City of Albuquerque Stormwater Construction Site Inspection Report

**Re: Erosion and Sediment Control Permit F17E006-OP -Cheddar's Casual Cafe
Permit Compliance Inspection**

To: Curtis Cherne, City Hydrologist, Planning Department
Cc: Shahab Biazar, Senior Engineer Hydrology, Planning Department
From: Paul Olson, Senior Engineer Construction Management, Planning Department
Subject: Cheddars SWPPP Inspection on April 26, 2013

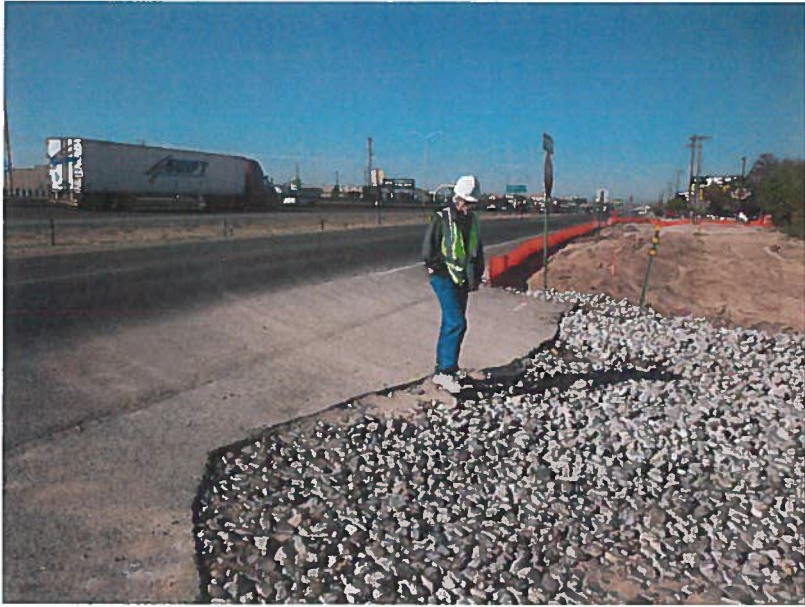
1. SWPPP sign was not present and SWPPP was not on site and no documentation of where it was located. No phone numbers of responsible person(s) was present.

2. A new entrance was added that needs to be shown on the ESC plan. The entrance has the appropriate rock on the property sign, but can not use dirt for a ramp over the curb. Cold mix asphalt with a temporary pipe may be acceptable at this location.

3. The upstream (northeast) culvert is blocked. It does not appear that any blockage or treatment is necessary here, but the cobble risks upstream properties. Remove.

4. The south end of the channel along the frontage road should use cobble for a silting basin rather than the orange silt fencing. In addition, if the silt fencing does hold back water it would direct to the frontage road. Remove silt fencing and use gravel or appropriate material for a sediment trap set lower than the adjacent roadway.

5. The southern edge of the property should be graded to direct water to the sediment basin at the southwest corner. The silt fence on fill material is not adequate to protect the neighboring property and will likely wash out.

6. The construction entrance to the frontage road requires continued regular sweeping.

Construction entrance requiring sweeping.

Northeast culvert that needs cobbles removed.

Silt fence at southeast corner to be removed and replaced with appropriate material

Southside of site that needs to be graded to sediment basin.
